SUMMIT AT POWDER MOUNTAIN PHASE 1C - COPPER CREST ROAD ROADWAY AND UTILITY CONSTRUCTION DRAWINGS

MAKE CORRECTIONS
Weber Fire District
10/23/2013 10:52:11 AM

PHASE 1C CONSTRUCTION
CIVIL TITLE SHEET

TYPICAL ROADWAY SECTION A-A
 (36' RIGHT OF WAY SECTION)
 STA: 10+00.00 TO 20+88.66

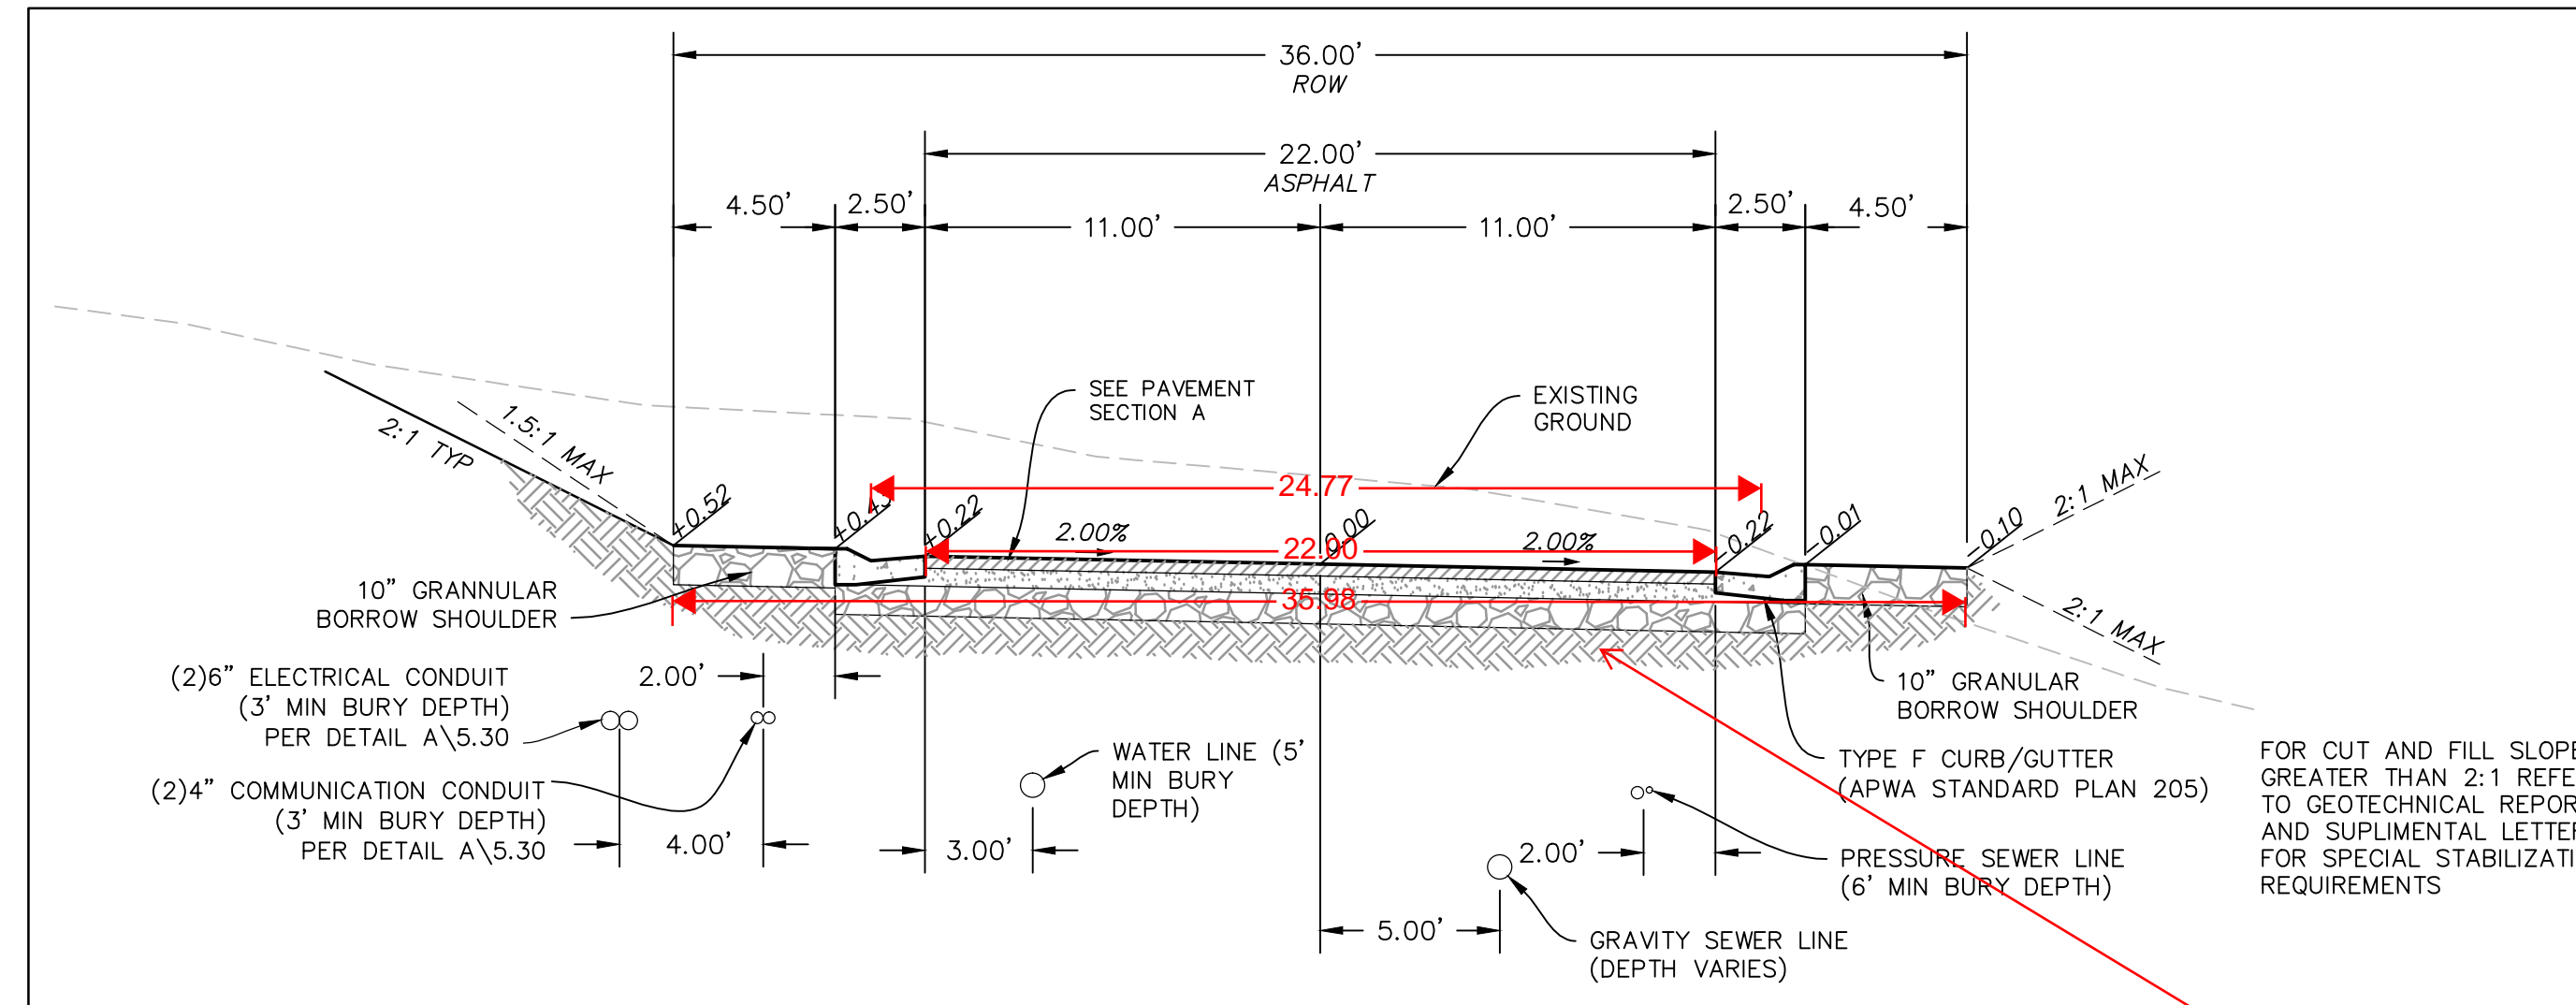
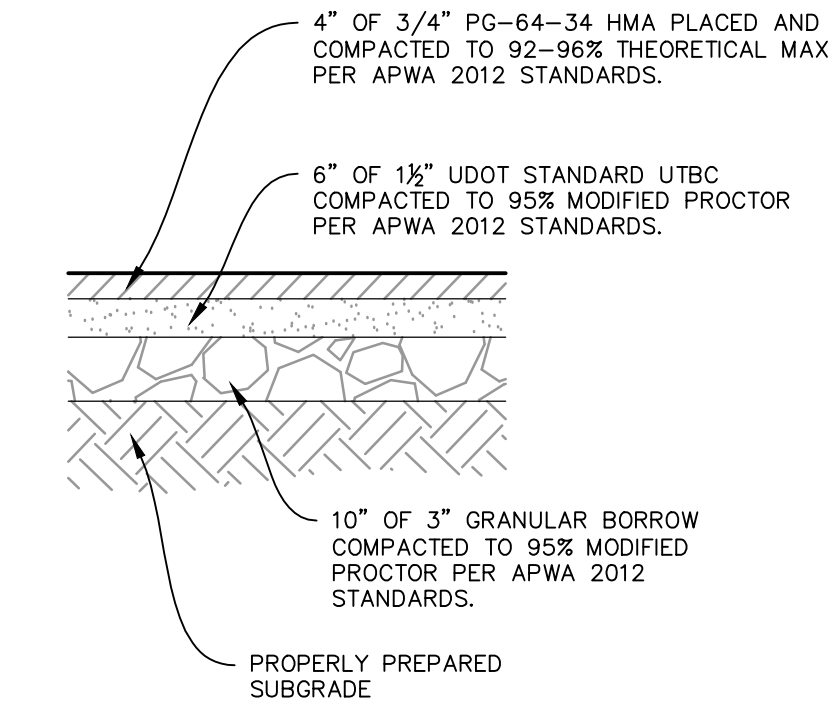
While this indicates an adequate road width of over the 20 foot minimum, page 6 road measurements average only 18 feet in width.
